Remarks

This amendment responds to the official action of May 31, 2007, wherein claim 1 and the claims depending from claim 1 were rejected on grounds of new matter. In particular, the phrase in claim 1 defining the union nut 6 as "flush with an outer surface of the handgrip, over the longitudinal length of the union nut" was considered to lack adequate support in the disclosure as filed.

Docket Nos. D4700-380
[P42416US]

Fig. 1

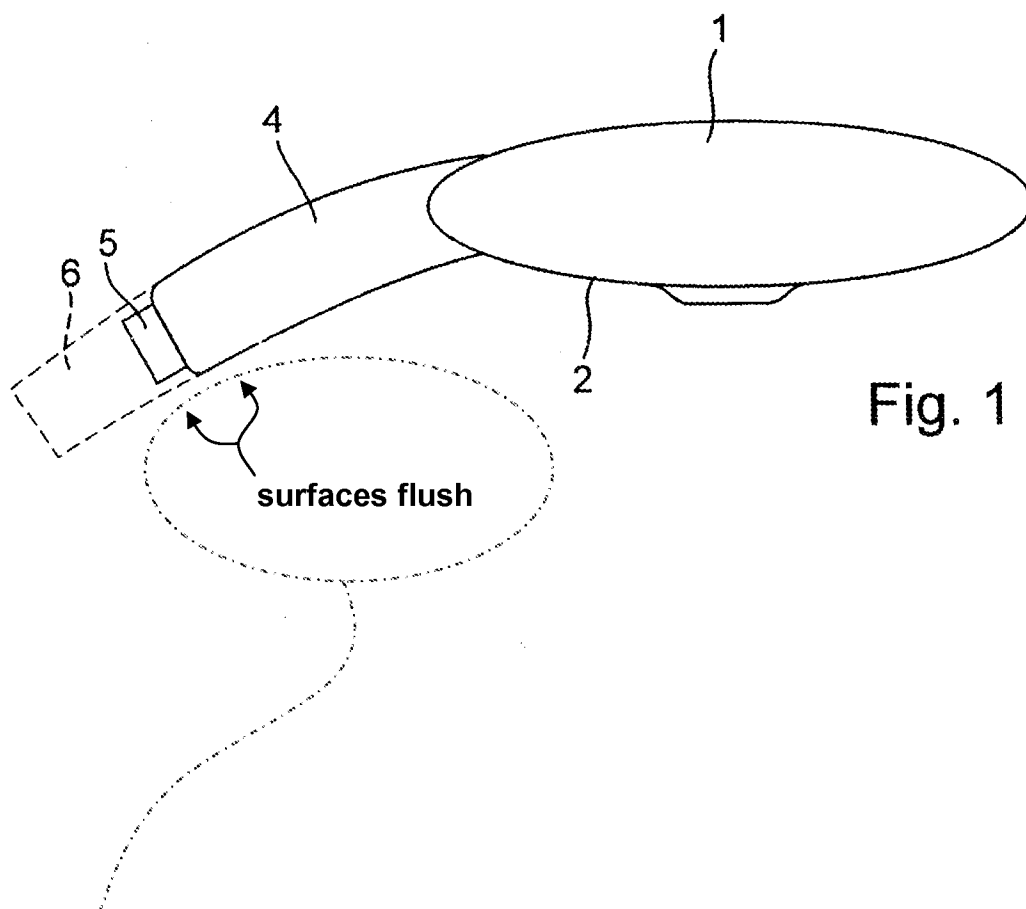
In the comments associated with the rejection, the examiner implies that the union nut cannot be flush because the union nut is somewhat tapered in the drawings as filed. Reconsideration is requested. There is no basis to assume that in order for surfaces to be flush or to continue one another that the surfaces must be right-cylindrical surfaces. The dictionary definition of "flush" with respect to surfaces refers to the continuation of a given surface by an adjacent surface that is "flush" with the given surface, namely the surface is continued in the same plane, across the line of abutment. This is consistent with applicant's usage in the application as filed and in the claims as amended. Furthermore, this aspect distinguishes the claimed invention from the prior art of record.

There is no inconsistency between the dictionary definition of "flush" for the surfaces of the grip and the union nut, versus the depiction in Fig. 1 wherein the union nut tapers slightly away from the grip. The term "flush" refers to the fact that the surfaces of the grip and the union nut are continuous where they abut such that the surface of the grip is continued (elongated) by the surface of the union nut.

Applicant has amended claim 1 to reflect the text in the specification. Applicant proposes to amend Fig. 1 to include a legend that points to the surfaces that are flush. No new matter is presented.

Applicant requests entry of the proposed formal drawings. The proposed drawings reflect the slight taper of the union nut seen in the informal drawings as filed. A slight taper is advantageous for a hand shower that can be received in a fixed receptacle or removed from the receptacle when manipulated by hand. No new matter is presented.

Added legend and arrows
to Fig. 1
